Well Name: LOCO 13 FEDERAL	Well Location: T18S / R30E / SEC 13 / SESE /	County or Parish/State: EDDY / NM
Well Number: 1	Type of Well: OIL WELL	Allottee or Tribe Name:
Lease Number: NMLC028990A	Unit or CA Name:	Unit or CA Number:
US Well Number: 3001533561	Well Status: Producing Oil Well	Operator: EOG RESOURCES INCORPORATED

Notice of Intent

Procedure Description: EOG PROPOSES TO PLUG AND ABANDON THIS WELL USING THE ATTACHED PROCEURE, THE CURRENT AND PROPOSED WELLBORE DIAGRAM IS ALSO ATTACHED.

Loco 13 Federal #1 – P&A

Proposed Wellbore Diagram:

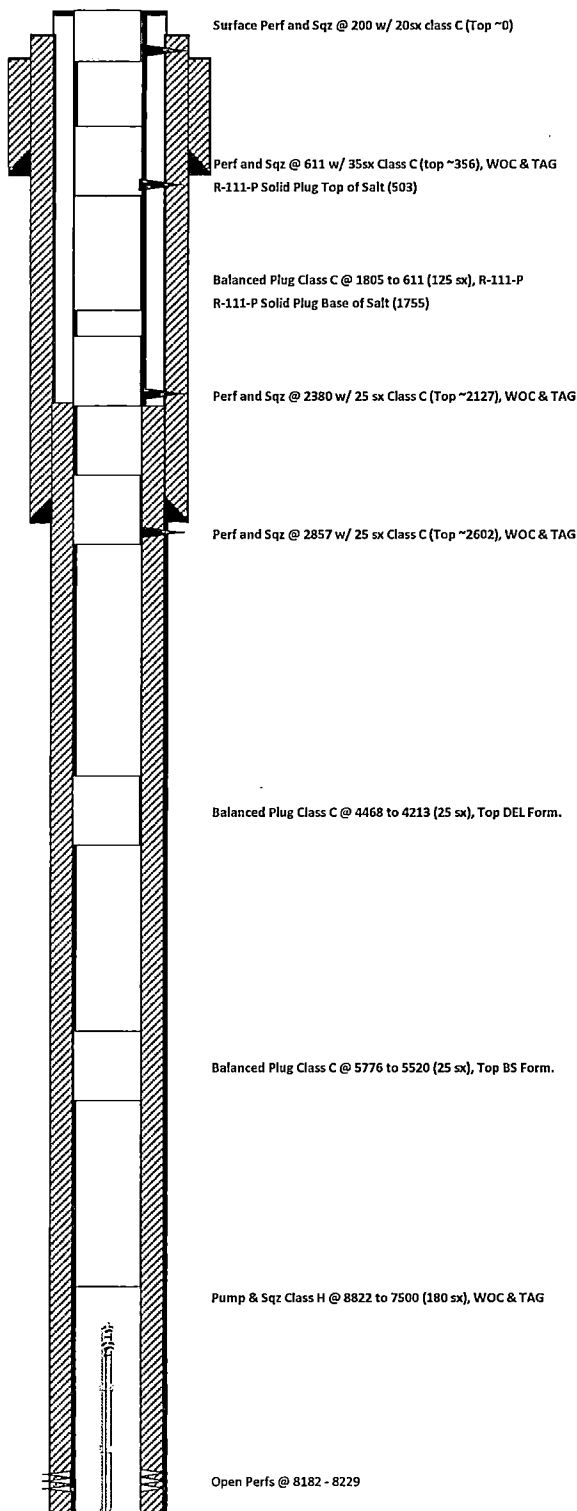
Sundry ID		2707246					
Plug Type	Top	Bottom	Length	Tag	Sacks	Cement Class	Notes
Surface Plug	0.00	100.00	100.00	Tag/Verify			
Shoe Plug	505.39	611.00	105.61	Tag/Verify			
Fresh Water @ 570	514.30	620.00	105.70	base no			
Top of Salt @ 785	727.15	835.00	107.85	Tag/Verify	195.00	C	Perf and squeeze from 835' to surface. Verify at surface. (In 83 sxs/ Out 112 sxs)
Base of Salt @ 1790	1722.10	1840.00	117.90	Tag/Verify			
Yates @ 1915	1845.85	1965.00	119.15	If solid base no need to Tag (CIBP present and/or Mechanical Integrity Test), If Perf & Sqz then Tag, Leak Test all CIBP if no Open Perforations	56.00	C	Perf and squeeze from 1965' to 1722'. WOC and Tag. (In 24 sxs/Out 32 sxs)
Shoe Plug	2738.83	2867.00	128.17	Tag/Verify	25.00	C	Spot from 2867' to 2738'. WOC and Tag.
Delaware @ 4395	4301.05	4445.00	143.95	If solid base no need to Tag (CIBP present and/or Mechanical Integrity Test), If Perf & Sqz then Tag, Leak Test all CIBP if no Open Perforations	25.00	C	Spot cement from 4445' to 4301'. WOC and Tag.

If solid base no need to Tag (CIBP present and/or Mechanical Integrity Test), If Perf & Sqz then Tag, Leak Test all CIBP if no Open Perforations			
Bonesprings @ 5726	5618.74	5776.00	157.26	ns	25.00	C	Spot cement from 5776' to 5618'. WOC and Tag.
				If solid base no need to Tag (CIBP present and/or Mechanical Integrity Test), If Perf & Sqz then Tag, Leak Test all CIBP if no Open Perforations			
Retainer/Packer @ 7600	7474.00	7650.00	176.00	ns	205.00	H	Set Retainer/Packer at 7600'. Pump and squeeze below to perforations 180 sxs CL H. Spot 25 sxs on top CL H. WOC and Tag at 7491'.
TOF @ 7618	7491.82	7668.00	176.18	base no			
Perforations Plug (If No CIBP)	8132.00	8758.00	626.00	Tag/Verify			
Shoe Plug	8770.90	8960.00	189.10	Tag/Verify

No more than 2000' is to be allowed between plugs in open hole, and no more than 3000' between plugs in cased hole.

Class H >7500'

Class C <7500'
